**RECALL R00DR
RE-NOTIFICATION**

R00DR

BLUE BIRD BODY COMPANY RECALL R00DR BENDIX R12DC RELAY VALVE PLUMBING MODIFICATION INSTRUCTIONS

Figure 1

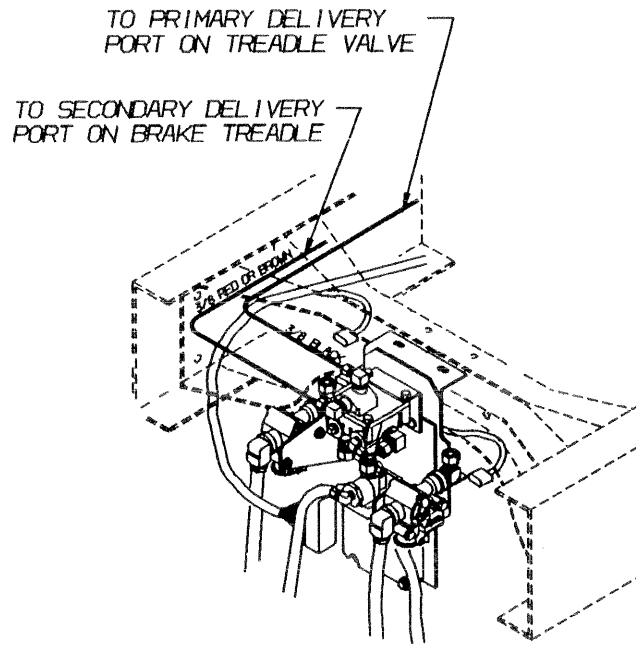
The defect involves the primary and secondary brake treadle valve airlines. These airlines were installed incorrectly.

The Bendix R12DC relay valve is located on the chassis crossmember in front of the rear axle. The Bendix R12DC relay valve should have two 3/8" air lines attached to the top portion of the valve. A 3/8" black airline should be attached to the top of the valve (primary port) and a 3/8" red (or brown) airline should be attached to the side adjacent to top port (secondary port). See Figure 1.

1. Apply parking brake.
2. Remove keys from ignition.
3. Chock wheels.
4. Inspect airline connections at the Bendix R12DC relay valve.
5. If airlines are plumbed according to Figure 1, no further action is necessary. Remove wheel chocks.
6. If not, proceed to instructions for airline relocation on page 2.

1. Remove keys from ignition.
2. Chock wheels.
3. Drain all air tanks.
4. Using a 5/8" open end wrench, remove the 3/8" black airline and the 3/8" red (or brown) airline from the Bendix R12DC relay valve.
5. Install the 3/8" black airline in the top port (primary port) of the R12DC relay valve and the 3/8" red (or brown) airline into the side port (secondary port) adjacent to the top port (See Figure 1 on page 1).
6. Close air tank drain valves.
7. Start engine and build up air pressure.
8. Stop engine. Remove key.
9. Have someone apply service brakes and check repositioned airlines for leaks.
10. Remove wheel chocks.
